Final Environmental Impact Report

Freeport Regional Water Project

Memorandum

Date: March 5, 2004
To: Interested Parties
From: Kurt Kroner
Re: Release of the Final EIR for the Freeport Regional Water Project

Figure 2-1 Intake Facility Layout2-4

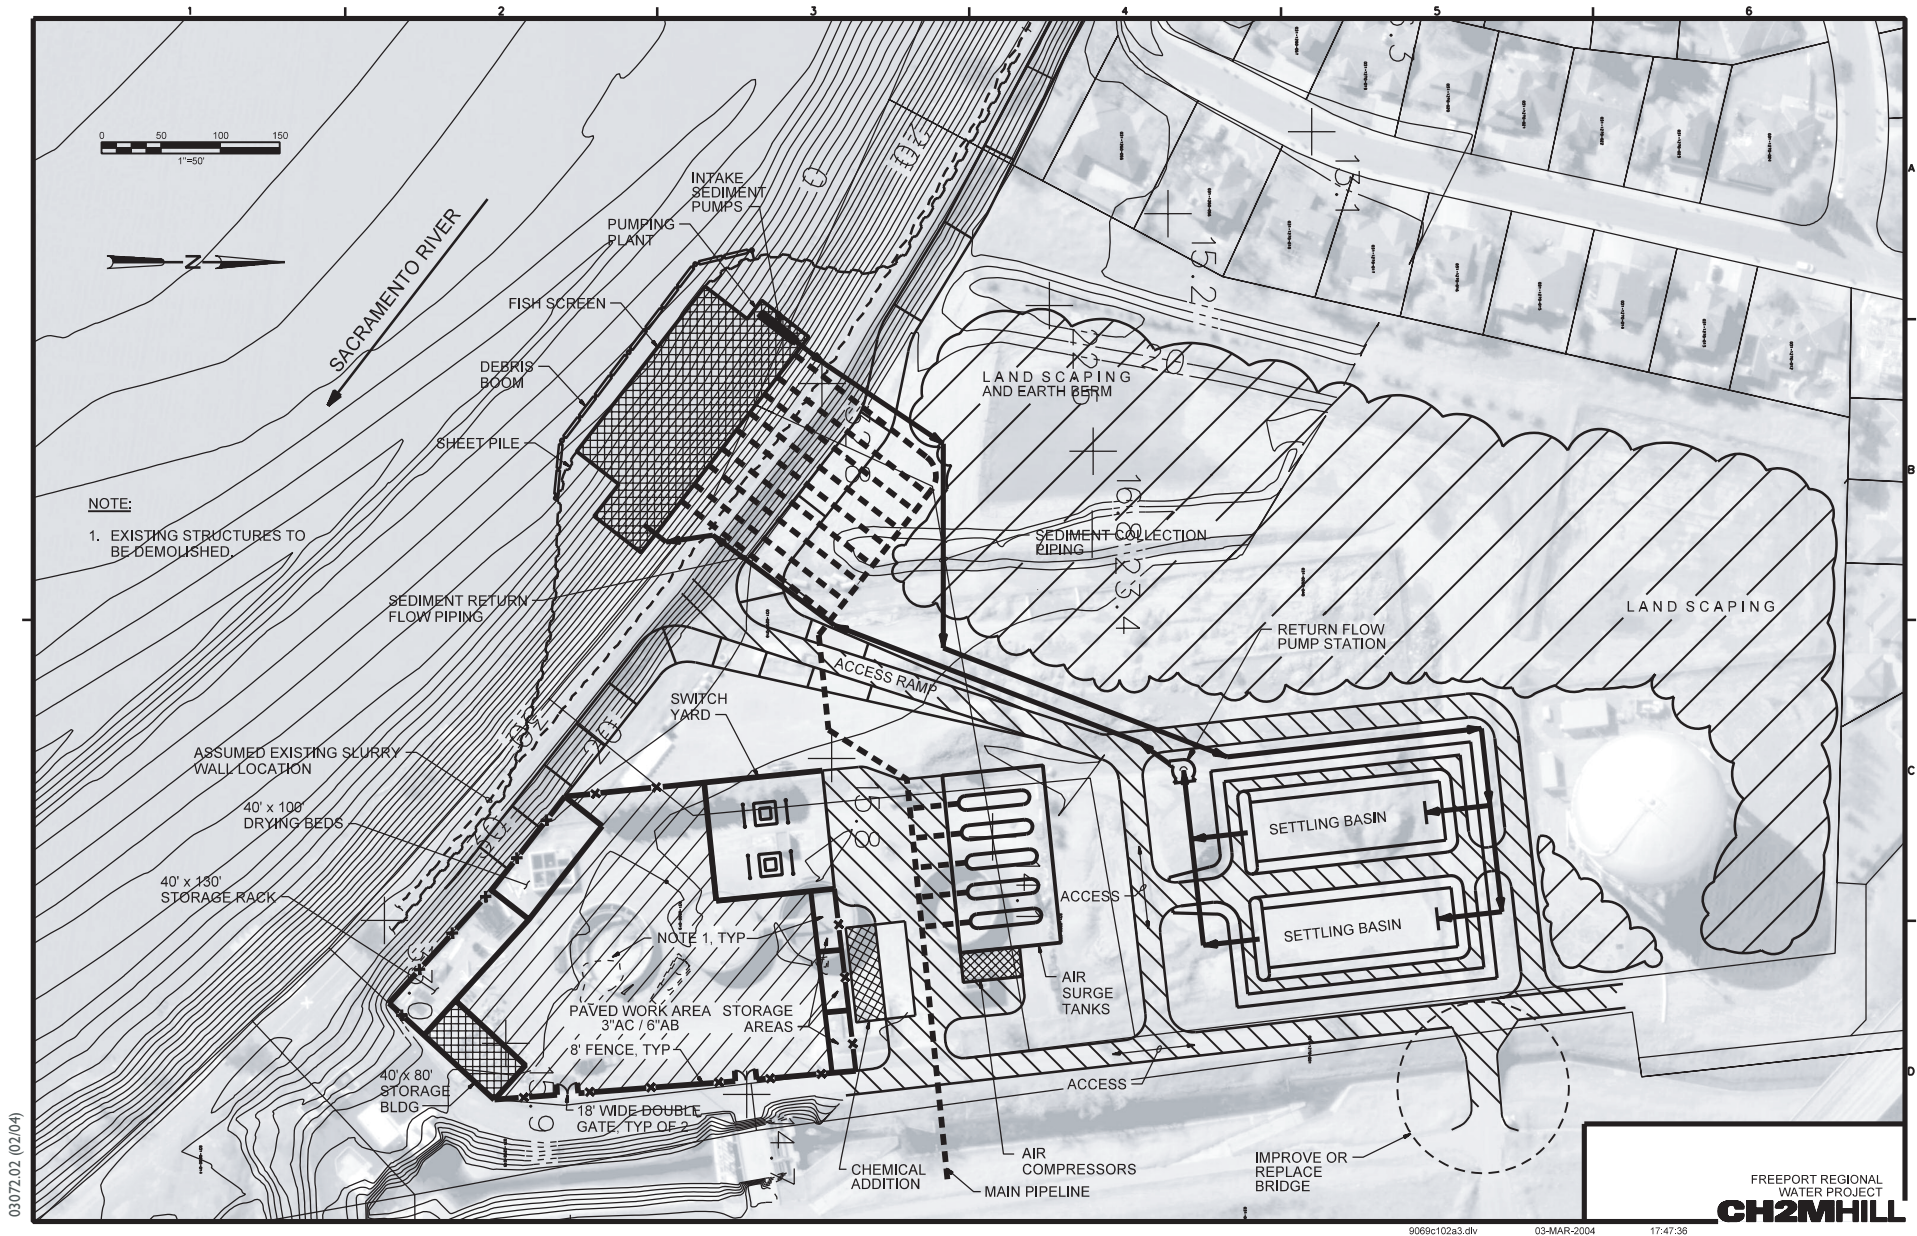
- 1) Please include the Alternative 6 pipeline alignment on the aerial photograph and in the corresponding legend shown on Figure 2-1.
- 2) Please name all roads discussed on page 2-11 under the subheading "Location," including Elsie Road and Wilbur Way, on Figure 2-1,

9. Pages 2-7 to 2-8 (Design/Operation and Maintenance) and Figures 2-4 and 2-6: These site plans should be revised to reflect the revised site plan developed by FRWA to minimize community impacts (see General Comments 1 and 2). To provide an adequate project-level analysis, the document also should provide a more detailed depiction/discussion of the design, construction and operation of the facilities identified on Figure 2-4 as "Switch Yard," "Chemical Addition," "Air Compressors," and "Air Surge Tanks," including any related facilities that are not shown, such as power lines to the Switch Yard, as well as an analysis of any potential adverse impacts that construction and operation of the facilities may have on the adjacent South Pocket residential neighborhood. L19-9a
L19-9b

FRWA failed to describe the proposed project's proximity to residences or properly identify the location of the intake facility on a map. DEIR Figure 2-4, labeled as the "Freeport Intake Facility Site Plan," and Figure 2-6, labeled "Freeport Intake Facility On-Site Settling Basins" fail to provide any frame of reference for the reader on the intake facility's location in relation to the nearest landmark or residence. Neither map contains a map scale. Figures 2-4 and 2-6 show a property that can be deduced to be immediately adjacent to South Pocket residences. However, the DEIR/DEIS fails to clearly show the existing residences.

- L19-9a.** The project description has been revised accordingly and is included in Chapter 2, "Project Update," included in this final EIR/EIS along with figure 2-1.

- Sp08-5.** Figure 2-1 in the final EIR/EIS shows the general location of the proposed intake facility in relation to residences.
- Sp08-6.** Figure 2-1 provides a layout of the relative positions and sizes of the different components of the project that are related to the intake facility and more description of these components has been added to the revised project description in Chapter 2.

- I35-8.** The layout of project elements at the intake site has been modified based on input provided by the City of Sacramento and members of the community. A revised layout is shown in Figure 2-1 in the final EIR/EIS.

Figure 2-2
Proposed Specific Location
of the Zone 40 Surface Water Treatment Plant

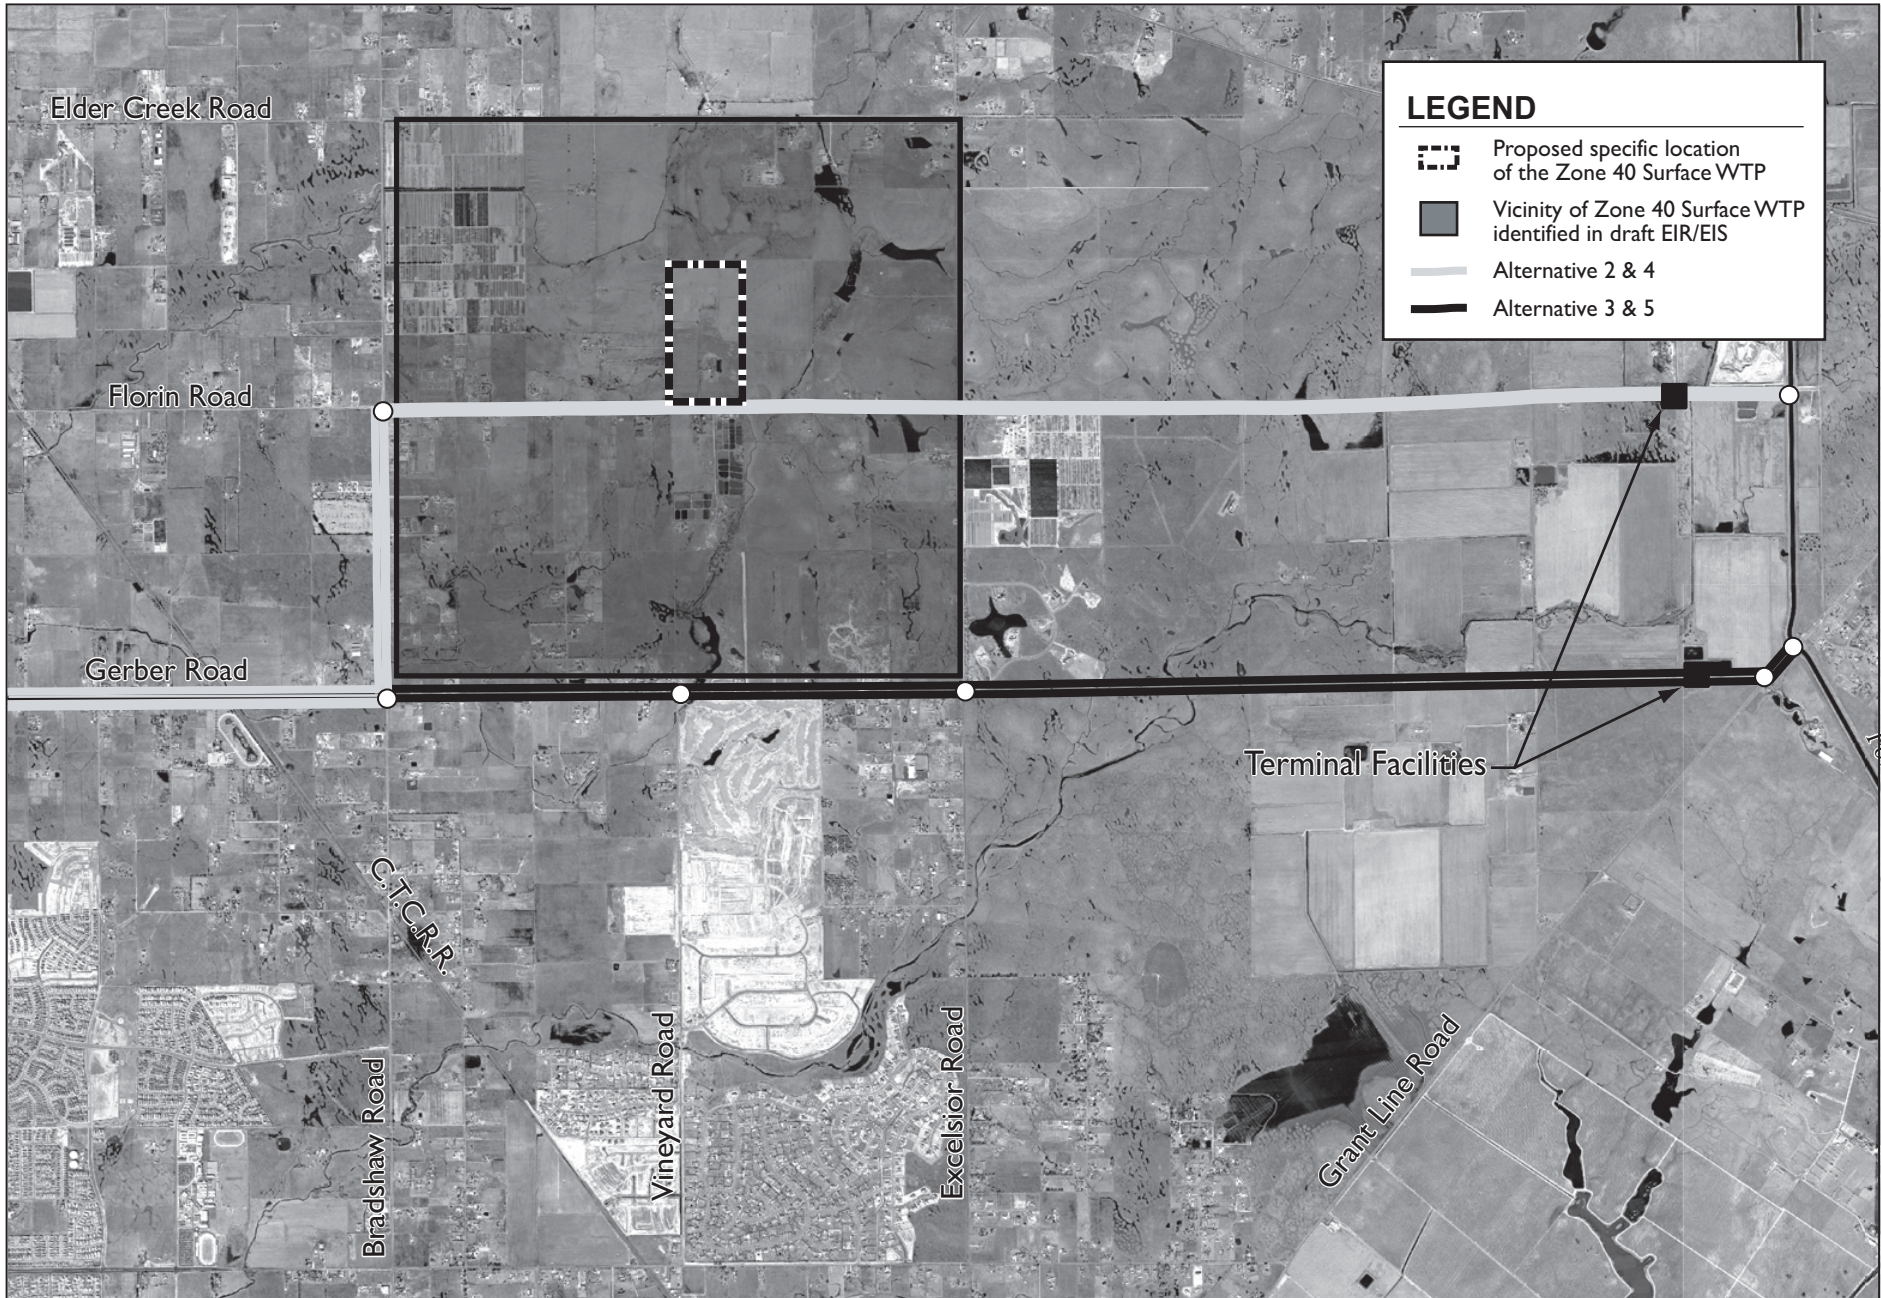
- L09-10.** As stated on page 2-14 of the draft EIR/EIS, the exact site for the Zone 40 Surface WTP has yet to be determined. However, SCWA recently secured an option on an 80-acre parcel on the north side of Florin Road, halfway between Bradshaw and Excelsior Roads. The general vicinity is identified as shown on Figure 2-1 and the analysis in the draft EIR/EIS is based on the Zone 40 WTP occupying 80–100 acres somewhere

SCWA has recently secured an option on an 80-acre parcel that could be used for the Zone 40 Surface Water Treatment Plant. The parcel is located within the general area described in the draft EIR/EIS and is at the north side of Florin Road halfway between Bradshaw and Excelsior Roads (Figure 2-2). The analysis in the draft EIR/EIS adequately addresses the resources and issues associated with this parcel. As described in the draft EIR/EIS, SCWA will ultimately purchase a parcel, potentially this one, and construct the Zone 40 Surface Water Treatment Plant at that location. However, additional detailed surveys and associated supplemental environmental documentation may be required before SCWA purchases the parcel and constructs the facility.

Figure 1
FRWP Intake Site Limitations

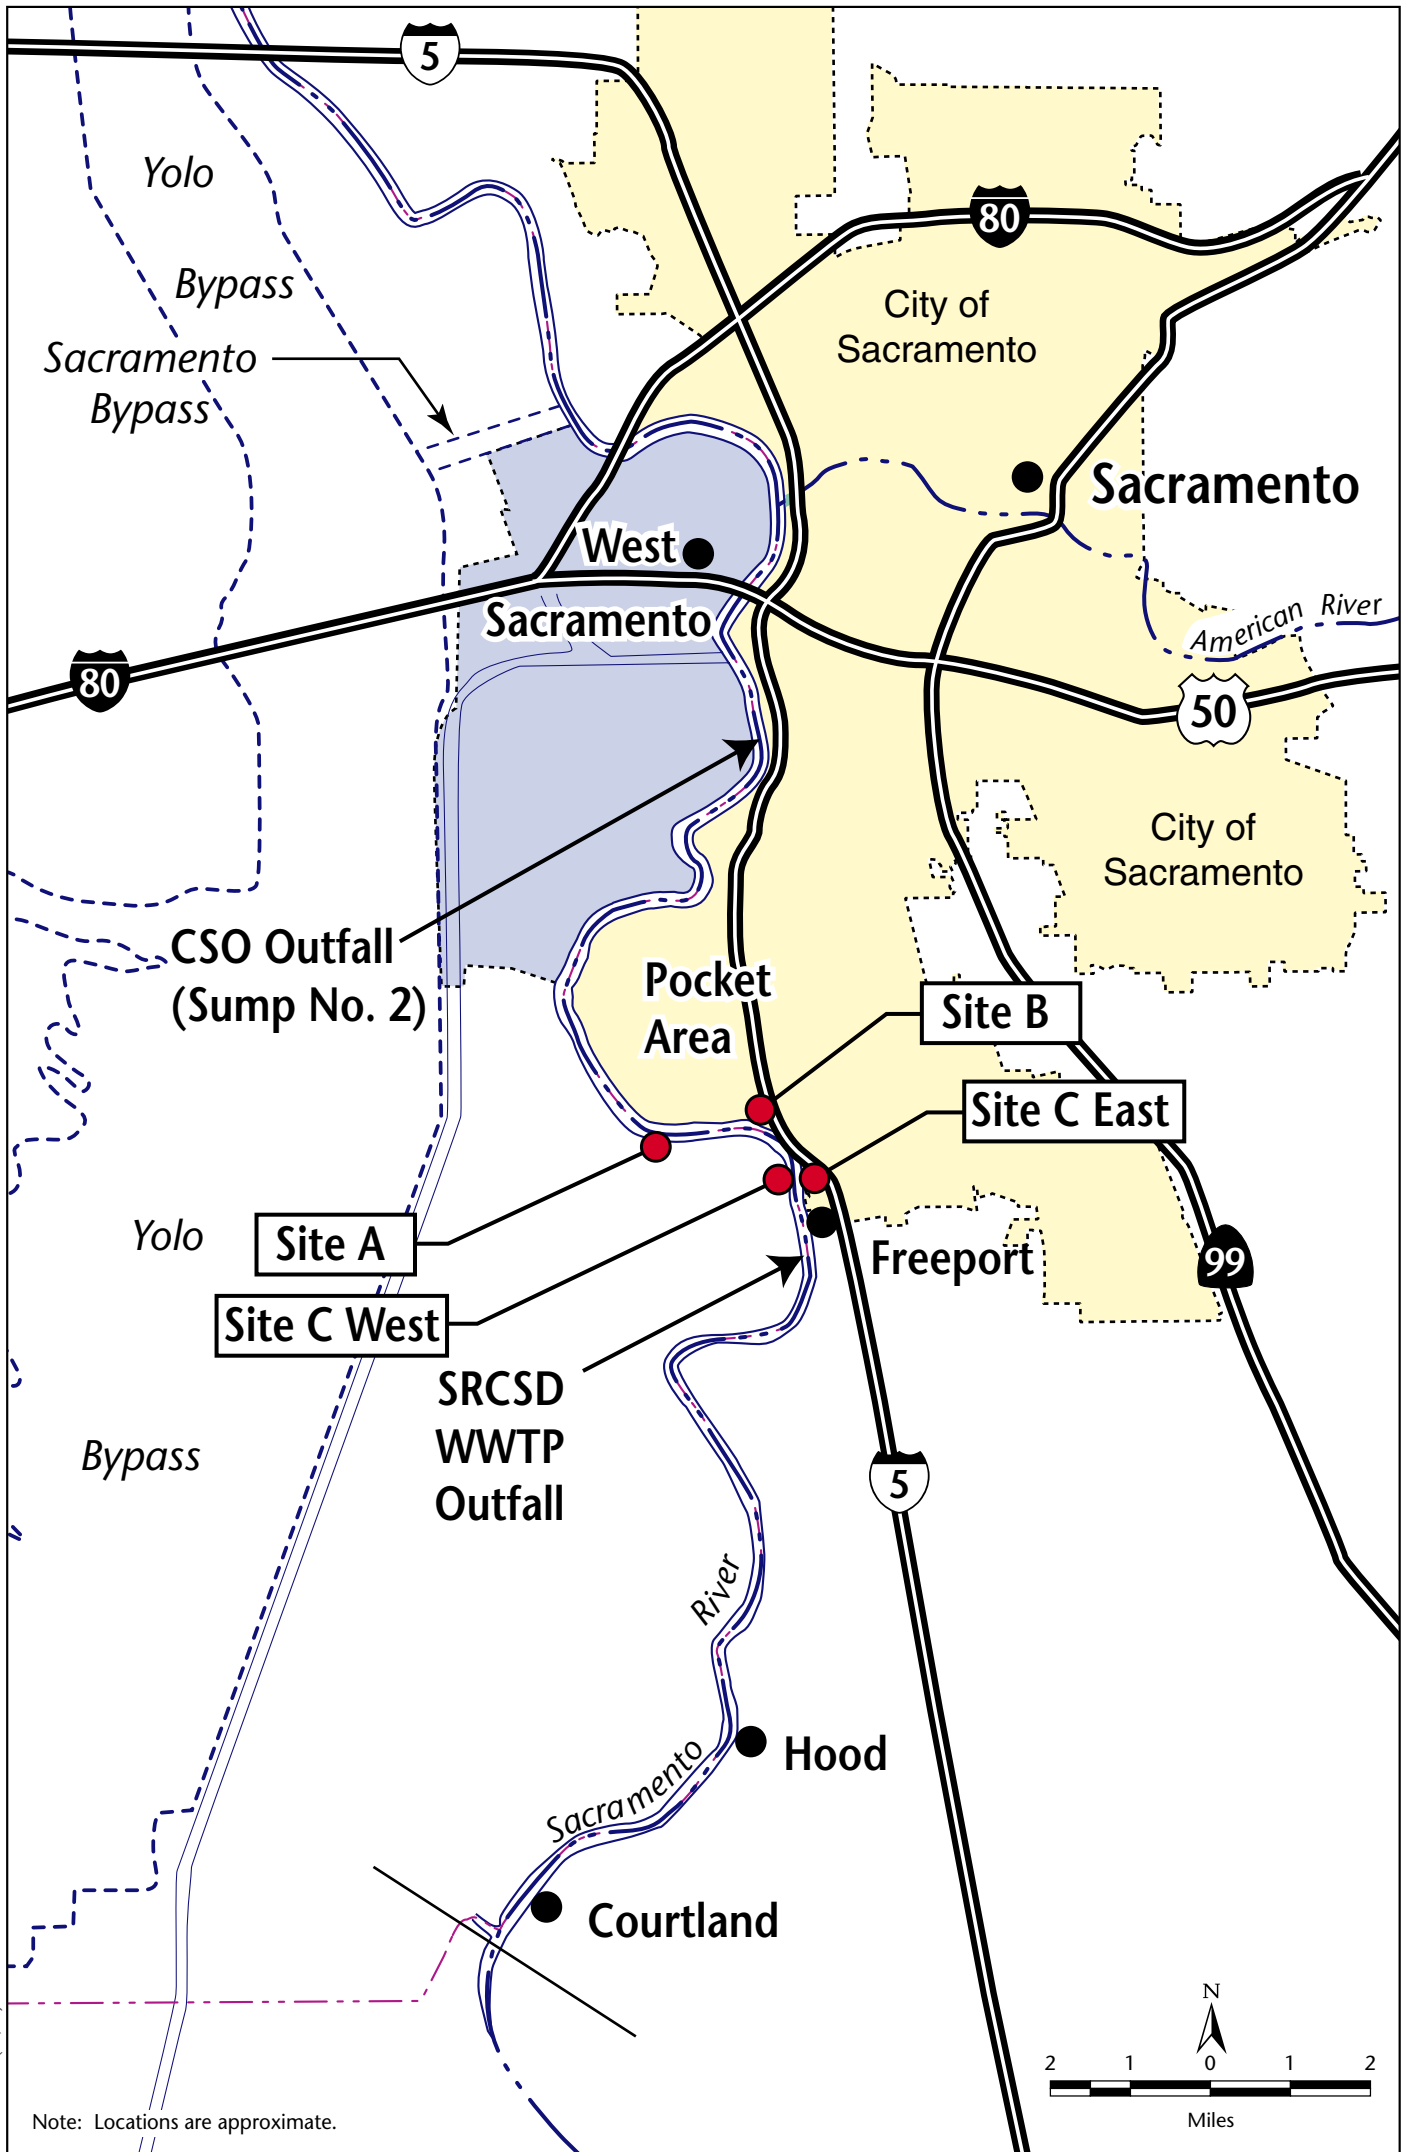
Locating the intake within any reasonable distance downstream of the WWTP outfall would be a breach of the member agencies' duty to protect the public's health and could be forbidden by regulatory agencies such as the Department of Health Services. The waste discharges carried by reverse flows that FRWA is attempting to avoid are infrequent events, yet are still of great concern. Downstream of the outfall, those waste discharges will be continuous and impossible to avoid.

In addition to the water quality issues posed by the SRCSD WWTP, the City of Sacramento operates a CSO that serves a portion of the City and County of Sacramento. Under most conditions, the combined flow of the sewers is directed to the SRCSD WWTP and is treated (secondary treatment) before discharge to the river. On occasion, however, storm flows are so great that the capacity of the WWTP is exceeded, and the excess flow is diverted to a series of smaller treatment plants, which treat the water to a lesser degree (primary treatment) than the SRCSD WWTP before discharge to the river. On even less frequent
